File ID: TMP-3008

Resolution authorizing the Mayor to enter into a Contract between the City of Huntsville, Alabama and the low bidder, SJ&L General Contractor, L.L.C., for Goss Road Extension and Mass Grading, Base Bid, Option No. 2 and Option No. 3, Project No. 71-23-SP17.

**CONTRACT BETWEEN CITY OF HUNTSVILLE, ALABAMA
AND
SJ&L GENERAL CONTRACTOR, L.L.C.
FOR
GOSS ROAD EXTENSION AND MASS GRADING, BASE BID, OPTION NO. 2
AND OPTION NO. 3
PROJECT NO. 71-23-SP17**

**C9.2-R1**

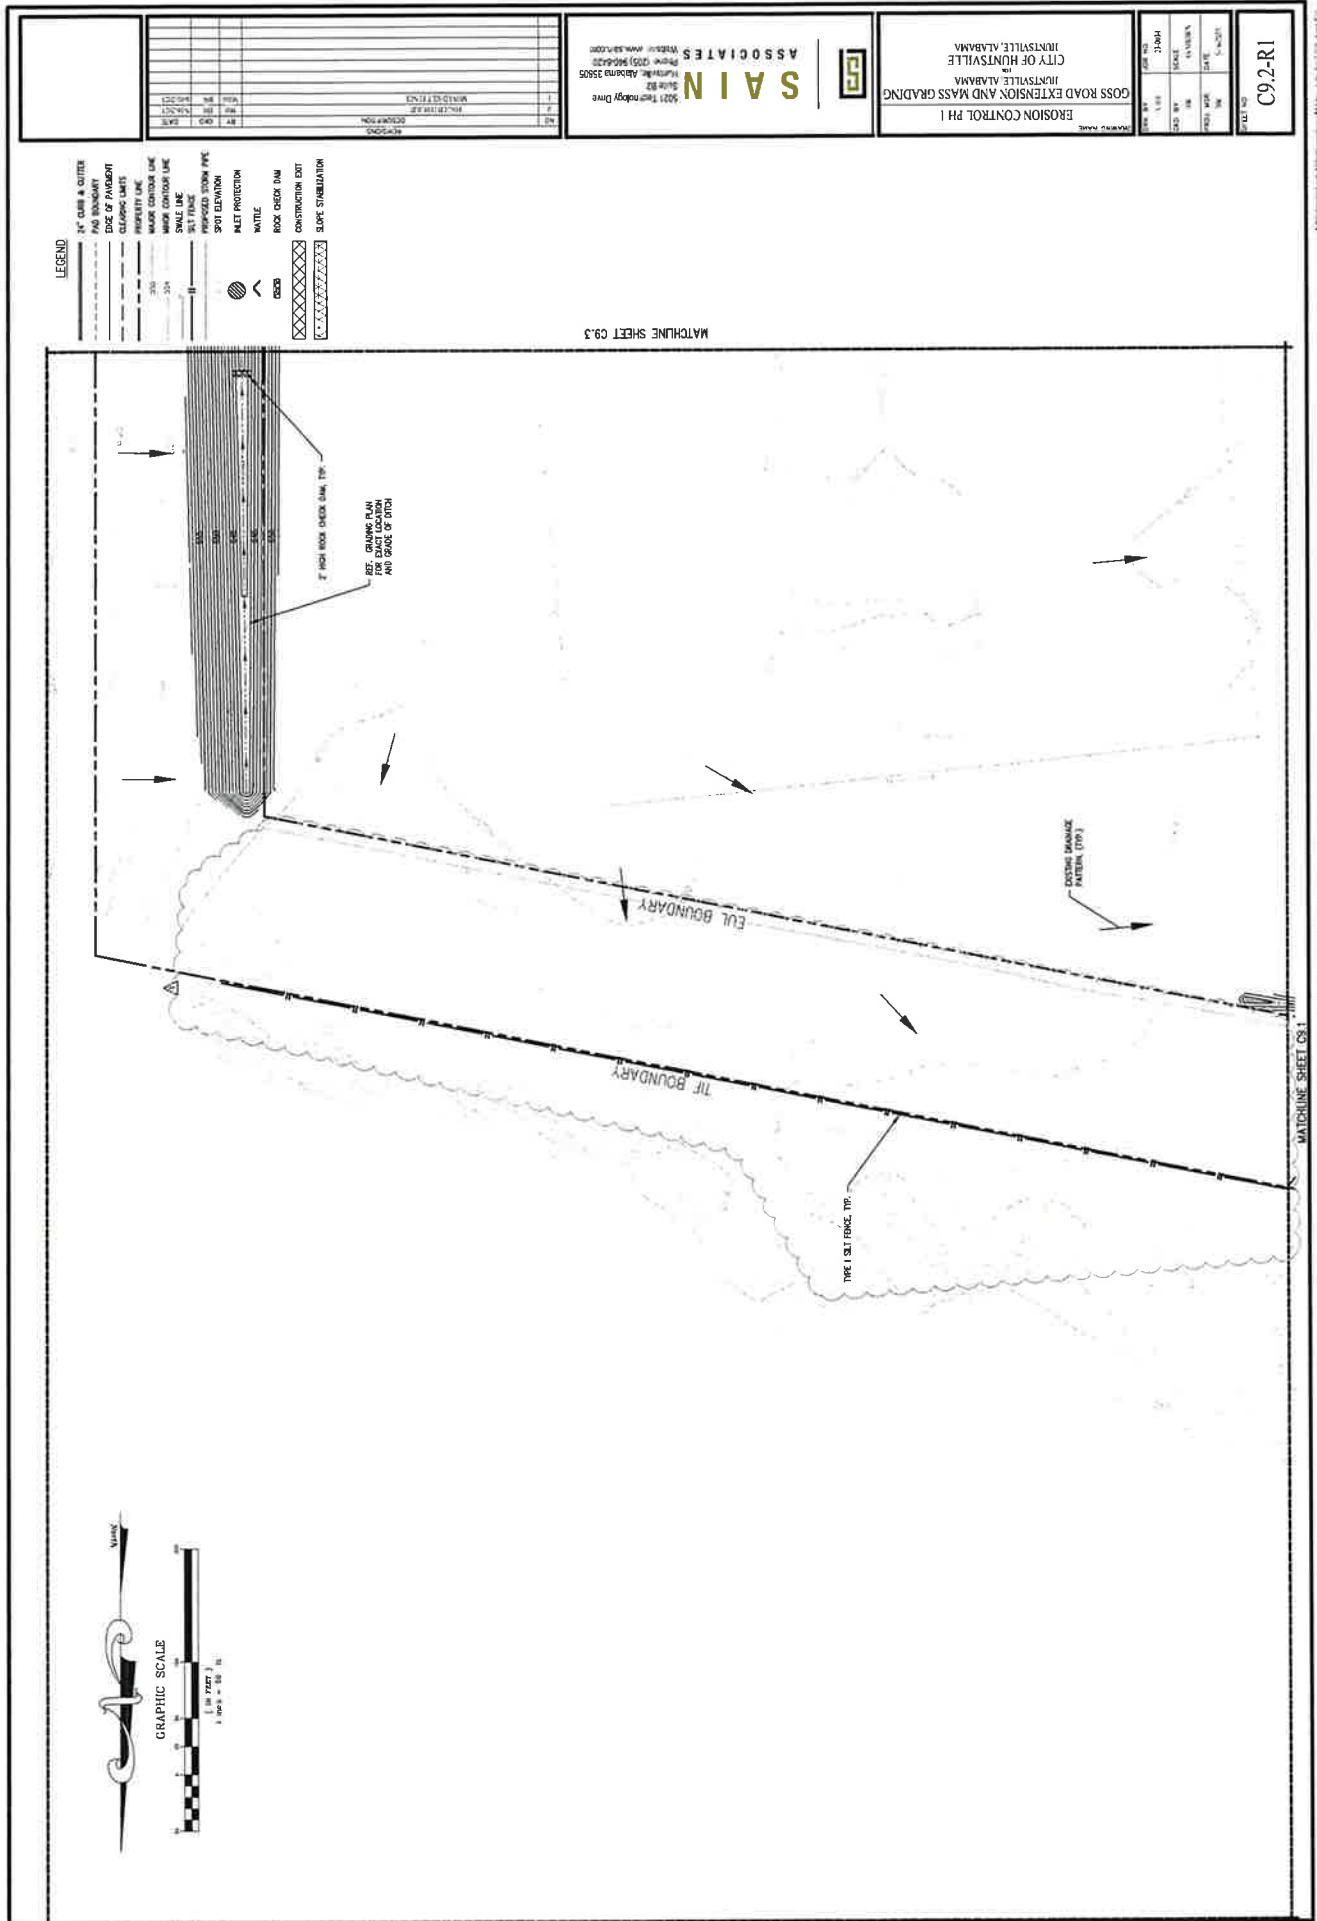
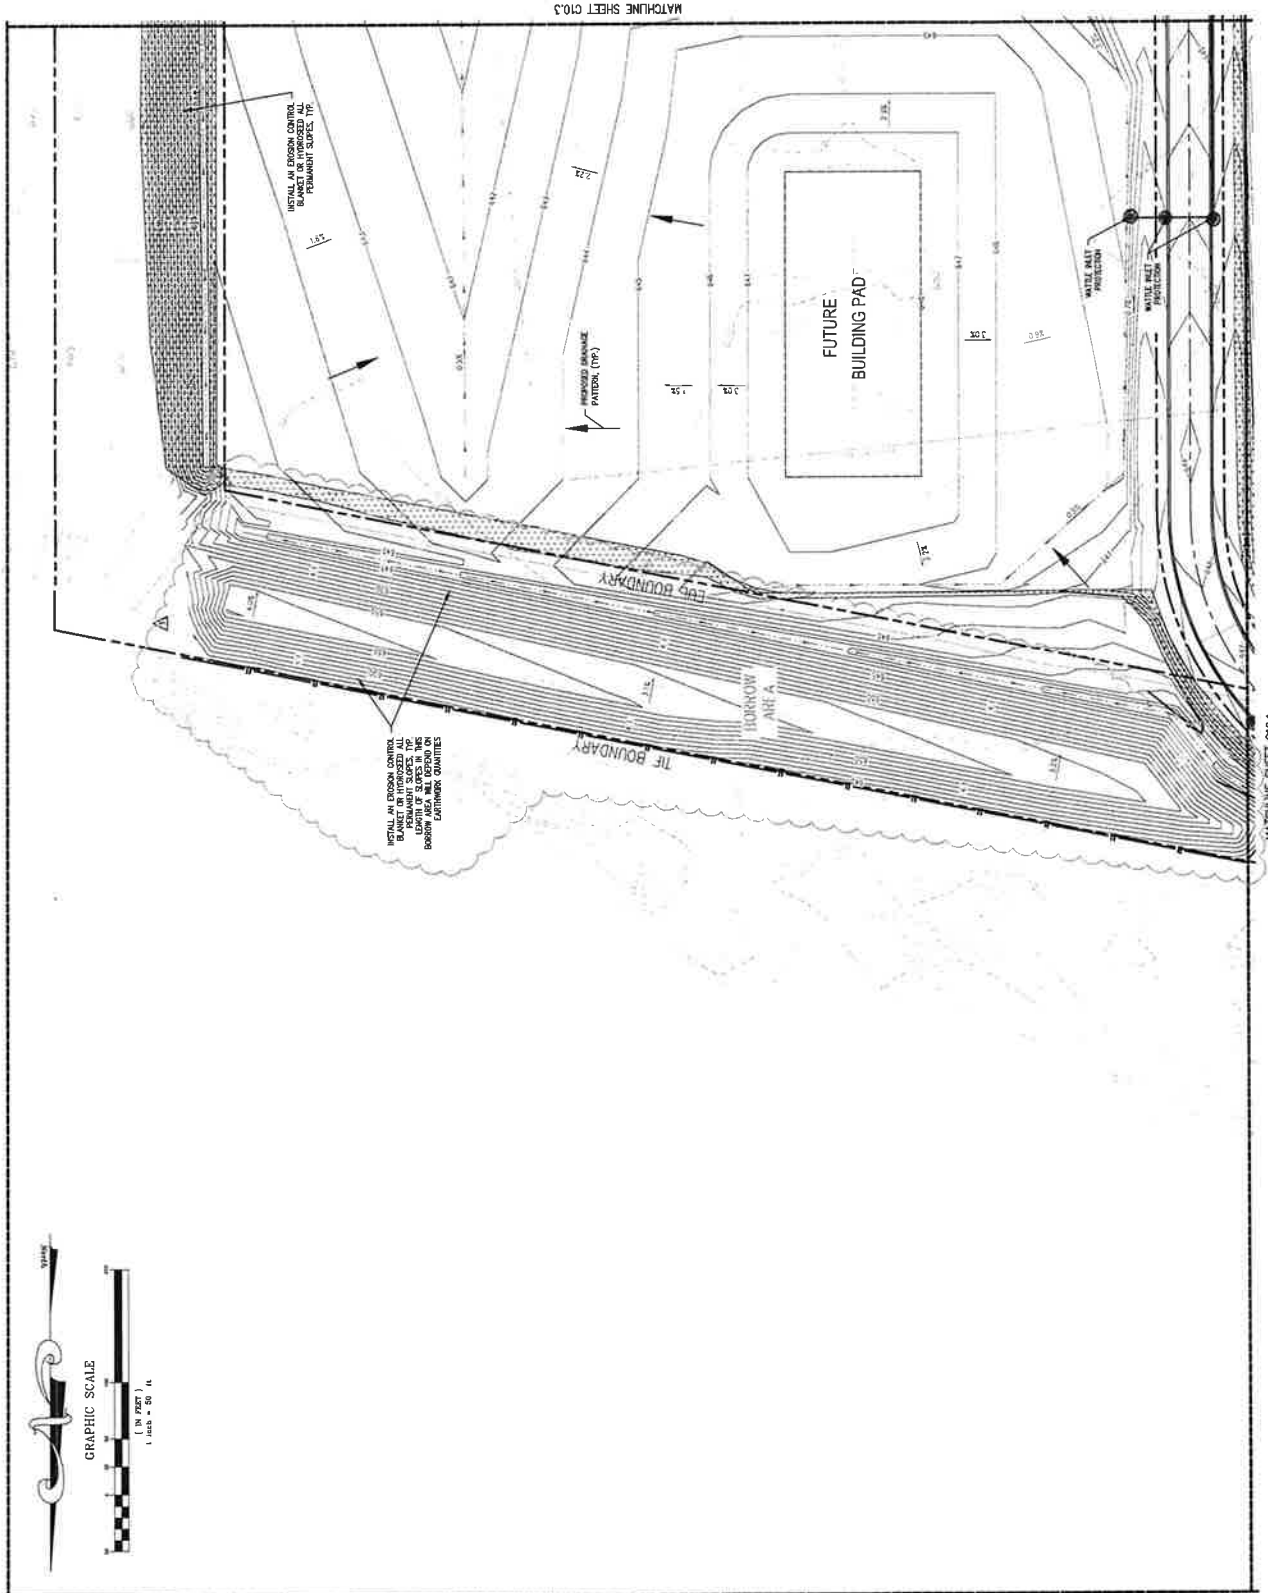
14. On sheets C3.1 and C3.3, road signs were added.
15. On sheet C7.1, added a note to the concrete spillway.
16. On sheet C9.1 and C9.2, moved silt fence.
